08.2-03

TECHNICAL BULLETIN

Delayed Engagement –
Powertrain 4L80-E Transmission –
Revised Specification Transmission

MODEL 1996 MY
XJ12 Sedan
VIN
754304-782045

ILLUSTRATION 1

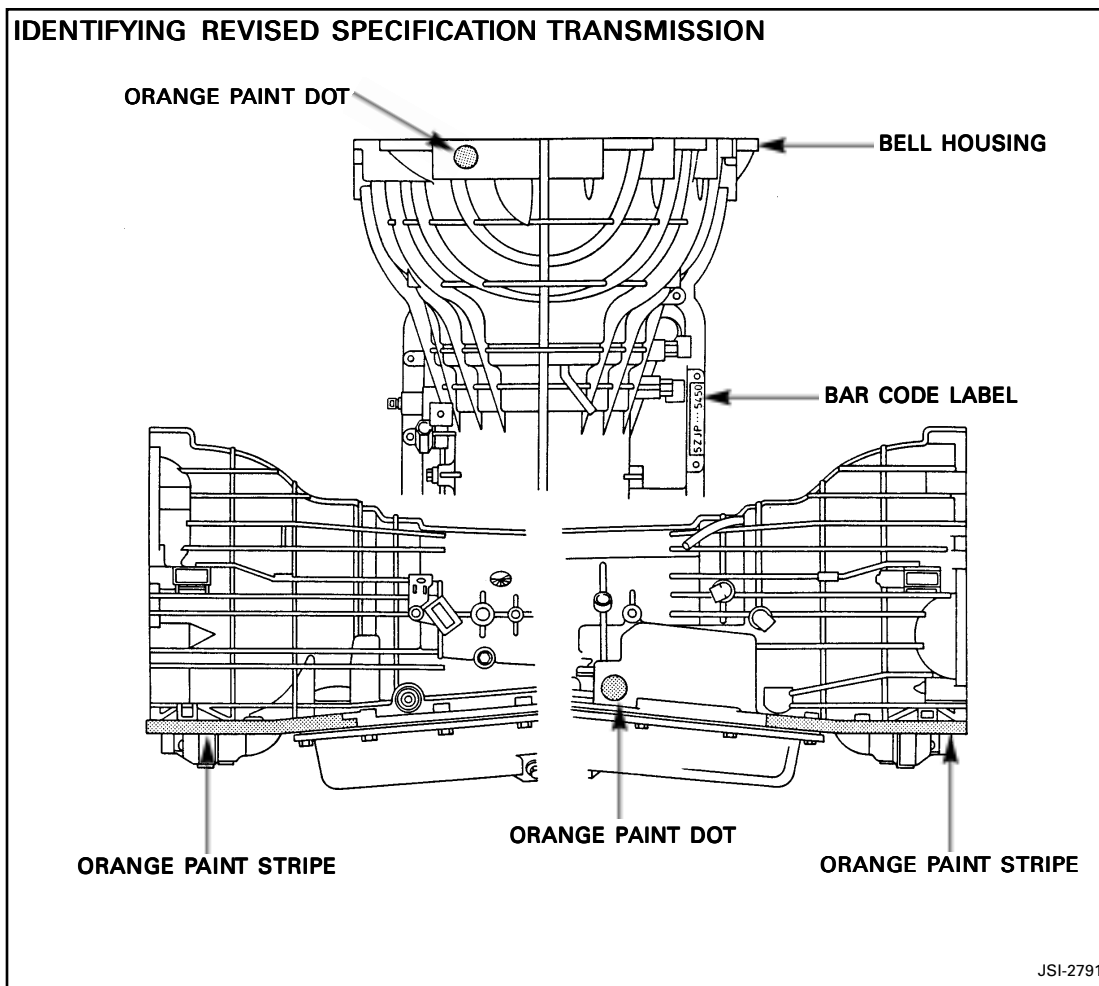
Transmissions with a serial number after 95ZJP5450 are the revised specification. Some transmissions with a lower serial number are the revised specification only if they are marked as shown in Illustration 1 on the following page.

- Orange paint dot, applied to the bell housing top, (not visible with transmission installed in vehicle).
- Bar code label on upper face of transmission case flange (visible by using mirror, with transmission installed in vehicle).
- Orange paint stripe at right side of the bell housing (on the continuation of the case flange).
- Orange paint dot, applied to the name plate surface on the right side of the transmission case.
- Orange paint stripe at left side of the bell housing (on the continuation of the case flange).

Serial no. 95ZJP5450 or greater.

Transmissions with serial no. before 95ZJP5450 with the following identification marks (Illustration 1):
